READ ME

Wechselrichter	SI 6.0_8.0H-13 / SI 6.0_8.0H-12
FW-Version	Firmware Paket 3.30.37.R
Release Datum	05/2024 (Download)
Update	Firmware update FW 3.30.37.R für alle Systemkonfigurationen, außer für Multiclustern-Systeme mit Eigenverbrauchserhöhung. Für Multiclustern-Systeme mit Eigenverbrauchserhöhung → FW 1.04.00.R.
Neue Funktionen	- Im Installationsassistenten der Geräte-WEBUI kann bei Auswahl „Offgrid-Anwendung“ der neue Spannungs- und Frequenztyp „240V/60Hz“ ausgewählt werden. - Neben dem bisherigen Verfahren „Multicast“ kann über den Geräteparameter „Messintervall“ das Verfahren für „SingleCast“ konfiguriert werden. Der Zähler sendet Daten an die Geräte als SingleCast, welche bei ihm die Daten abonniert haben. Einstellbare Werte sind „Aus, Automatik, 200, 600 und 1000 ms“ (→ Anlagenkommunikation/Messwerte/Zähler an Speedwire/<u>Messintervall</u>).
Sonstige Anpassungen	- Im Installationsassistenten der Geräte-WEBUI wurde bei Auswahl „Offgrid-Anwendung“ die Werkseinstellung für den Batterietyp vom Wert „VRLA Bleibatterie“ auf „Lithium-Ionen“ geändert. (→ Batterie/Batterie/Typ). - Der Einstellbereich des Batterie-SOC für den Lastabwurf (LoadShedding) in Offgrid-Anwendungen w

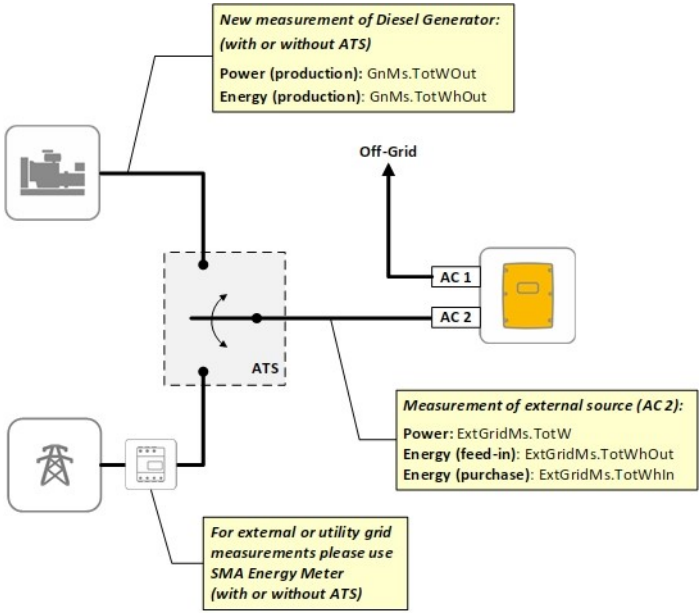
- **Separate measurement of Diesel Generators:**
With the new firmware are available separate measurement values of Diesel Generators connected to Sunny Island or Multicluster box systems. These values can be used to visualize p. ex. manually added devices in the Sunny Portal powered by ennexOS. In this case, the additional Energy

Meter is not needed. In case you wish to monitor the grid power you need always an Energy Meter (see diagram below).  New measurement of Diesel Generator: (with or without ATS) Power (production): GnMs.TotWOut Energy (production): GnMs.TotWhOut Off-Grid Measurement of external source (AC 2): Power: ExtGridMs.TotW Energy (feed-in): ExtGridMs.TotWhOut Energy (purchase): ExtGridMs.TotWhIn For external or utility grid measurements please use SMA Energy Meter (with or without ATS)
